Joint Meeting of Experts on the Regulations annexed to the European Agreement concerning the International Carriage of Dangerous Goods by Inland Waterways (ADN) (ADN Safety Committee)**Thirty-fifth session**

Implementation of the European Agreement concerning the International Carriage of Dangerous Goods by Inland Waterways (ADN): interpretation of the Regulations annexed to ADN

About Classification of zones – Zone 1**Transmitted by the informal group of Recommended ADN Classification Societies**

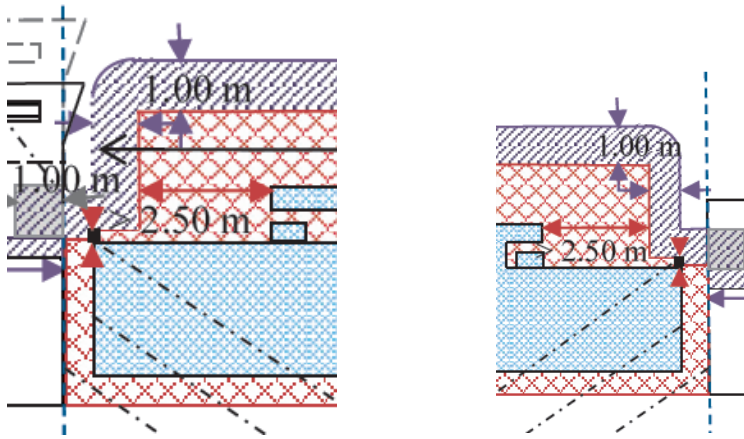
In English we read “at least a width of 2.50 m”; in French it is “diamètre de 2.50 m au moins”. The word “diameter” is better than “width” in the case of a cylinder. What about the German word “Kreisringbreite”.

How is this cylinder oriented? Vertical? horizontal? perpendicular to the opening plane?

5. The height of the cylinder would be defined.

6. The English version seems the clearest definition. With respect to the cylinder around the openings the group concluded that the prescribed cylindrical zone around the openings from Zone 0 should be a semi-sphere at the top of the cylinder with a radius of 2,5 m.
